SERVICE ACTION

Reference number:	SA-31-1547V2	Issued: 15 September, 2021
Subject:	Install Spacers to the Roof Blind Assembly	
Model(s):	DBX	
VIN range:	Refer to the separately published list of affected Vehicle Identification Numbers (VINs)	
Applicable to:	All Dealers	
Distribute to:	Head of Business After Sales Manager Service Manager Sales Manager	Warranty Staff Technician(s) Parts Staff

There have been changes for the roof blind assembly to reduce the possibility of minor cracks in the roof glass. To update vehicles, complete the workshop procedure that follows to install spacers for the roof blind assembly.

Figure 1

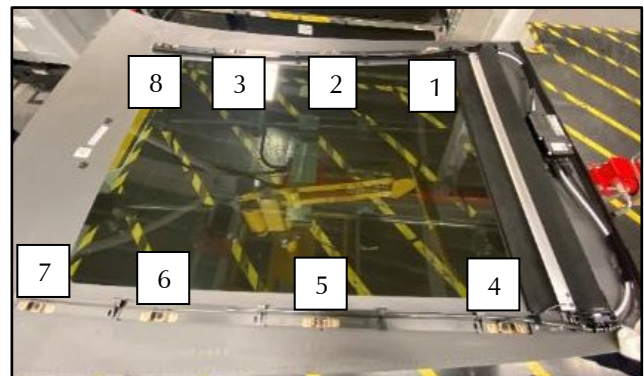
1. Remove the front overhead console assembly refer to (refer to Workshop Manual procedure 30.04.AD).
2. Remove the headlining (refer to Workshop Manual procedure 30.04.CA).
3. Complete steps 4 and 5 for the nuts in the sequence shown (refer to Figure 1).

Note: Start from the rear of the vehicle.

CAUTION: ONLY USE HANDTOOLS FOR THIS PROCEDURE. THIS WILL PREVENT DAMAGE TO THE GLASS.

Figure 3

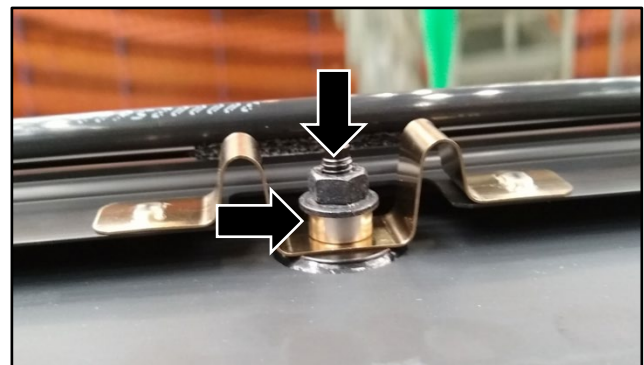
- 5. Install the spacer to the stud, then hand start the nut onto the thread.
Use a manual torque wrench to torque the nut to 2.6Nm (refer to Figure 3).

CAUTION: DO NOT USE POWER TOOLS TO TORQUE THE NUTS. THIS CAN CAUSE DAMAGE TO THE GLASS.
